Aero Technologies, LLC

SERVICE LETTER AT2016-1

SUBJECT: Flyweight design change.

MODEL AFFECTED: All PCU5000 and PCU5000X

AT1438504 Flyweight Assembly

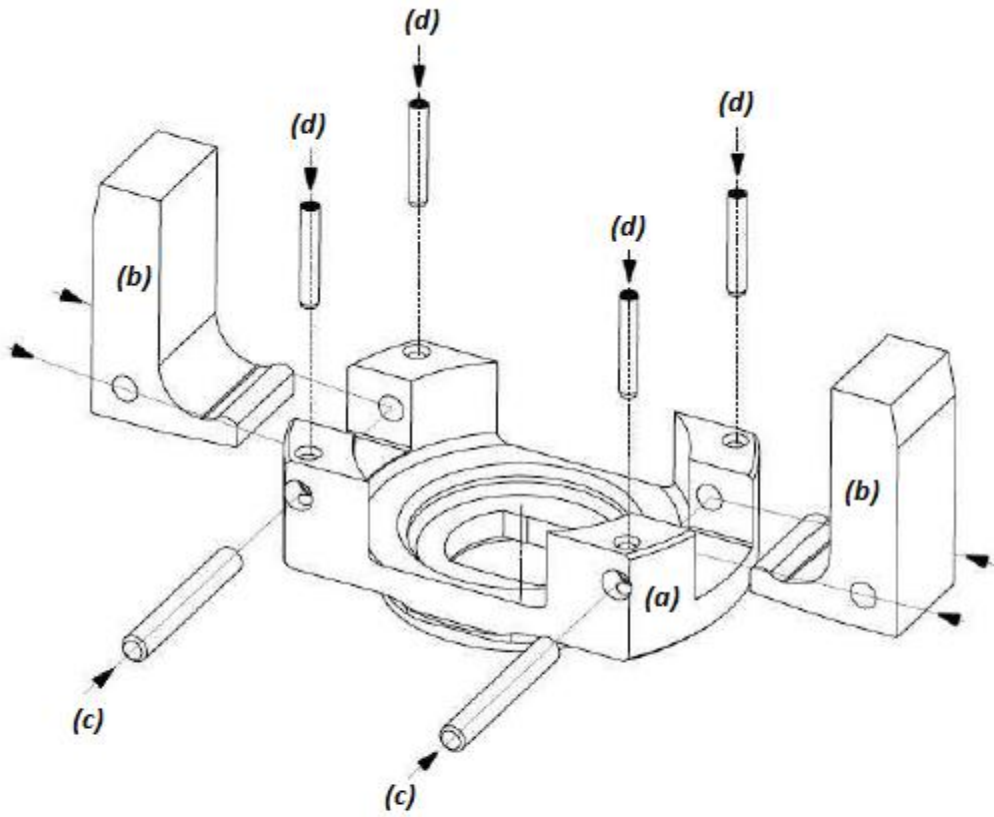
NEW FLYWEIGHT DESIGN TO REPLACE CURRENT DESIGN REQUIREMENTS

- 1) Current Flyweight assembly part number AT1438426 is still able to be overhauled until the supply of Safety Spring part number AT1430591 is exhausted.
- 2) New Flyweight Assembly part number AT1438504 (drawing page 2).
 - a) AT1430685, Flyweight head
 - b) AT1430522, Flyweight (requires 2)
 - c) AT4420170, Needle (requires 2)
 - d) AT4402020, pin (requires 4)

AT1438504 is a direct replacement for the AT1438426 Flyweight assembly and does not change fit, form, or function of the PCU5000 governor.
